DEPARTMENT OF HIGHWAYS ONTARIO

FOUNDATION INVESTIGATION REPORT

Reconstructed Q.E.W. - Mimico Creek
Woblooke Borough, Metropolitan Toronto
District No. 6 (Toronto)

W.J. 69-F-68 -- W.P. 314-65-04

| DRAWING NO. D-676-1 | | | REV. NO. 1 |

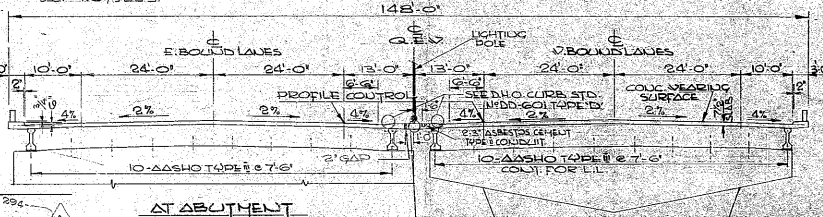
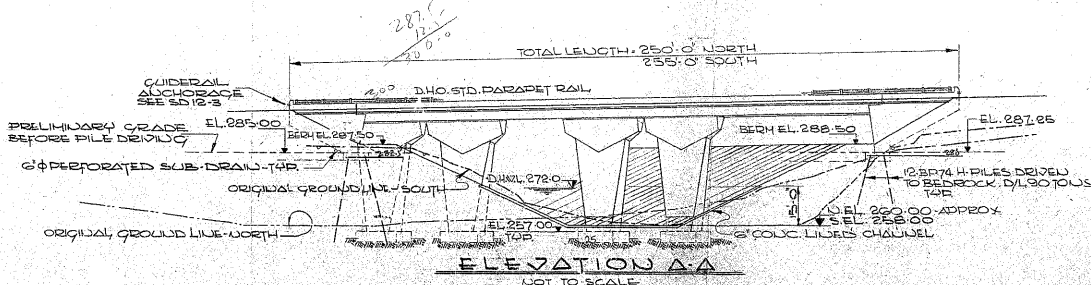
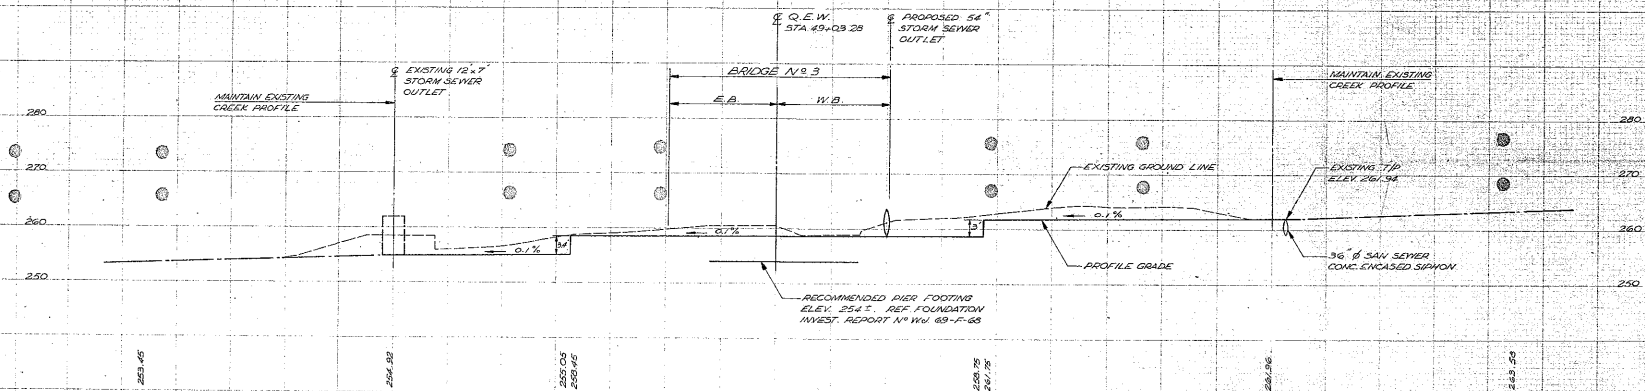
We have reviewed the bridge drawings for the
aforementioned structure (No's D-6761-1 and 3, dated
December, 1970); the following comment is being sub-
mitted.

The end-bearing 12BP74 steel H piles can be
designed using an allowable load of 95 tons/pile, rather
than the 90 tons/pile quoted on the two drawings.
